**Duke Energy Carolinas
Thermal-Hydraulic Statistical Core Design
Methodology**

**DPND-DPC-NE-2005-A
Revision 4a
Editorial**

December 2008

**SUBJECT: OCONEE NUCLEAR STATION, UNITS 1, 2, AND 3, ISSUANCE OF
AMENDMENTS REGARDING USE OF AREVA NP MARK-B-HTP FUEL (TAC
NOS. MD7050, MD7051, AND MD7052)**

FIGURE 2

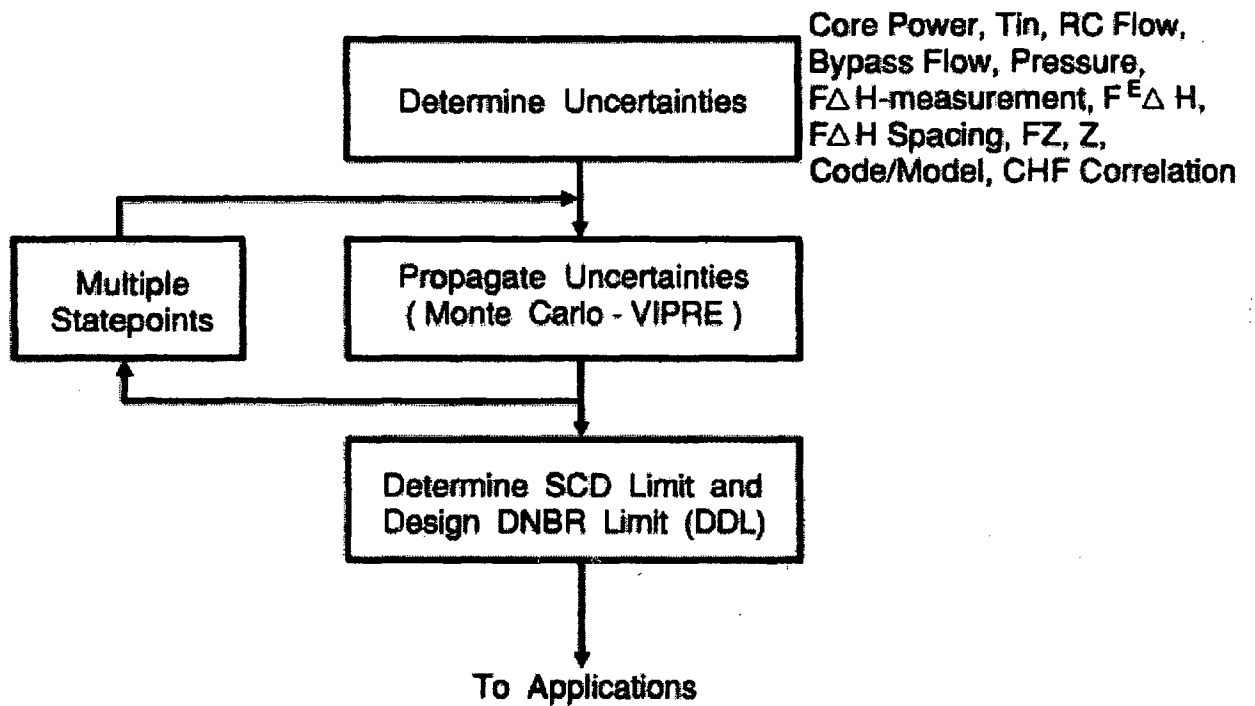
Additionally, the flow chart in Figure 2 also contains a typo. The Propagate Uncertainties box should have the words (Monte Carlo - VIPRE) underneath. The RSM is not used at all in the revised method described by the report. A corrected page 30 is also included.
